Amendments to the Drawings:

The attached sheets of Figure 1 and Figures 2 - 4 include corrections to Figure 1 and Figure 4 as indicated below.

Fig. 1

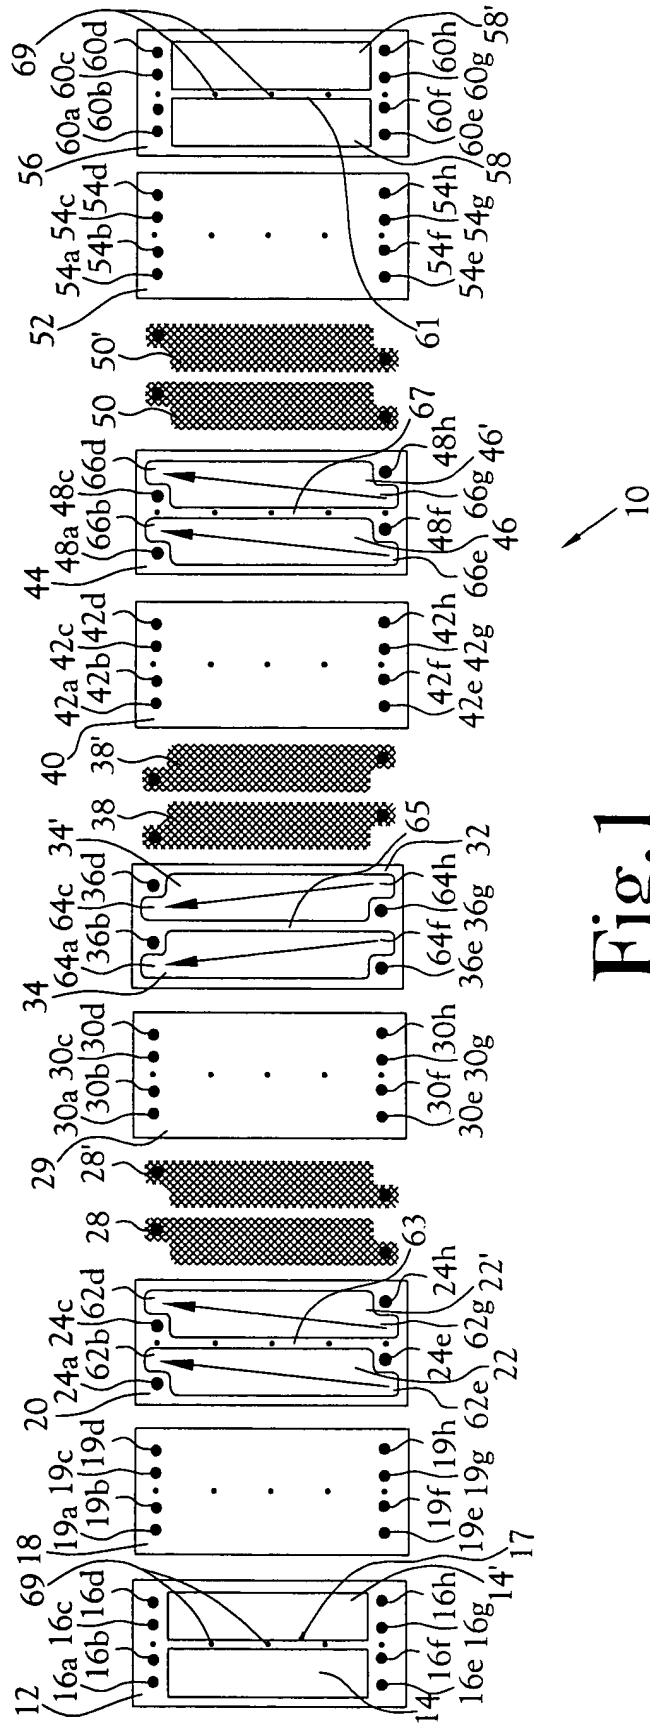
In Figure 1, element numbers for centrally positioned partitions 17, 63, 65, 67 and 61 are included for spacers 12, 20, 34, 44, and 56. Each partition is illustrated as having aligned holes therein, as indicated by element 69. In regards to spacer 12, a separate lead line and element number 14' is added. In regards to spacer 56, elements 14 and 14 are deleted, with each aperture identified as 58, 58'.

Fig. 4

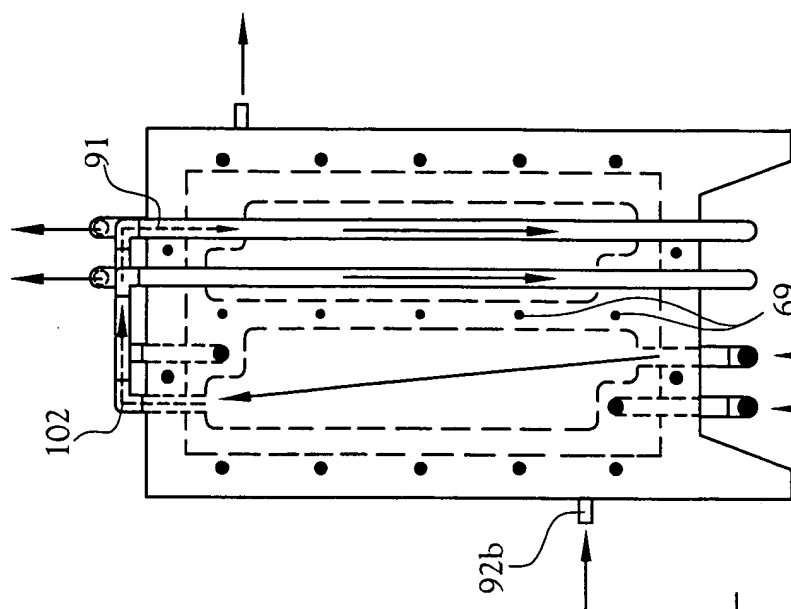
In Figure 4, the partition between the two apertures is illustrated as having aligned holes therein, as indicated by element 69.
